UNITED STATES PATENT AND TRADEMARK OFFICE

APPLICATION NO.	FILING DATE	FIRST NAMED INVENTOR	ATTORNEY DOCKET NO.	CONFIRMATION NO.
09/748,277	12/27/2000	Jae-Lag Ma	8733.363.00	4729

Office Action Summary

Fig. 1

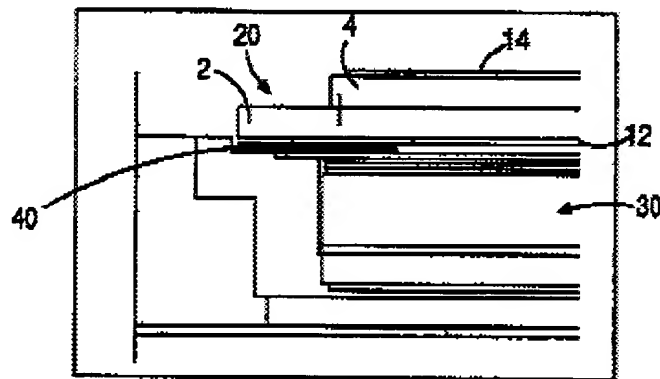
As to claims 6 and 9-12, APA discloses in Figures 1-4 (Specification pages 2-4), a dot matrix (Specification, Page 2, lines 18-22) liquid crystal display (LCD) device, comprising:

an upper polarizer, 14; on an upper substrate, 4;

a lower substrate, 4, on a lower polarizer, 12;

a backlight device, 30, disposed opposite and adjacent to the lower polarizer for emitting light toward the lower polarizer (Figure 1) (please note that adjacent does not preclude structures between those items considered to be adjacent, e.g., two houses may be adjacent despite the existence of an intervening garage);

wherein at least a black pad, 40, that acts as a light shield (Applicant's light shielding film) formed in a rectangular shape only along a peripheral portion (evident from Specification, Page 3, lines 11-14); and

wherein the light shielding film absorbs light (property of the color black).

APA does not explicitly disclose a lower polarizer that includes said light shielding film.
